**KEYSTONE ELECTRONICS CORP.**

2032 BATTERY HOLDER, SMT

| TOLERANCES                 | INCH   | MM   | CODE | DWG NO. |
|----------------------------|--------|------|------|---------|
| DECIMAL                    | ± .010 | [± ] | C    | 1060    |

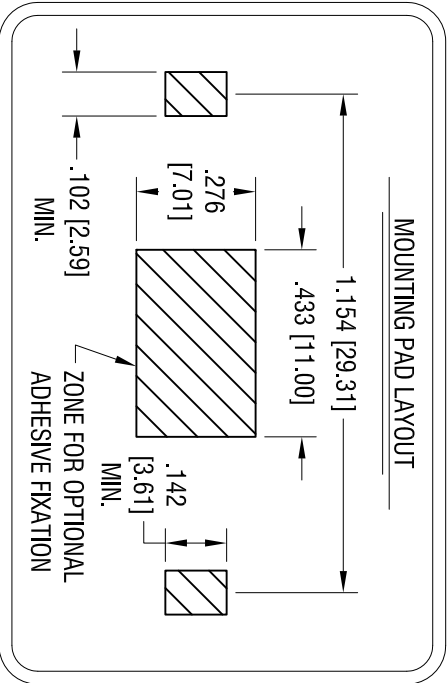
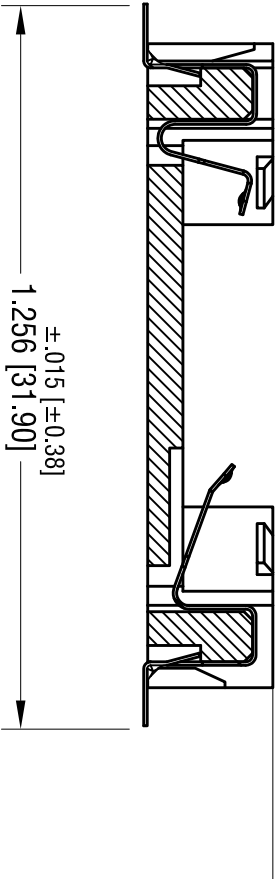
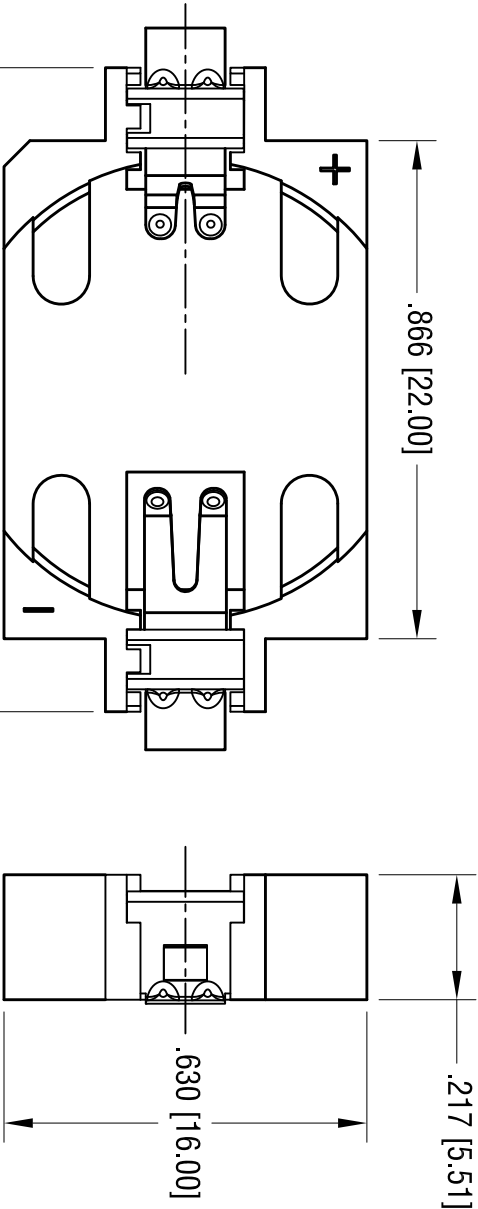
| DATE     | DESCRIPTION  | REV. |
|----------|--|------|
| 7.12.24  | CHANGE AS PER PCN 24-034<br>ADD STRENGTHENING RIBS TO<br>SOLDER LEADS. | M    |
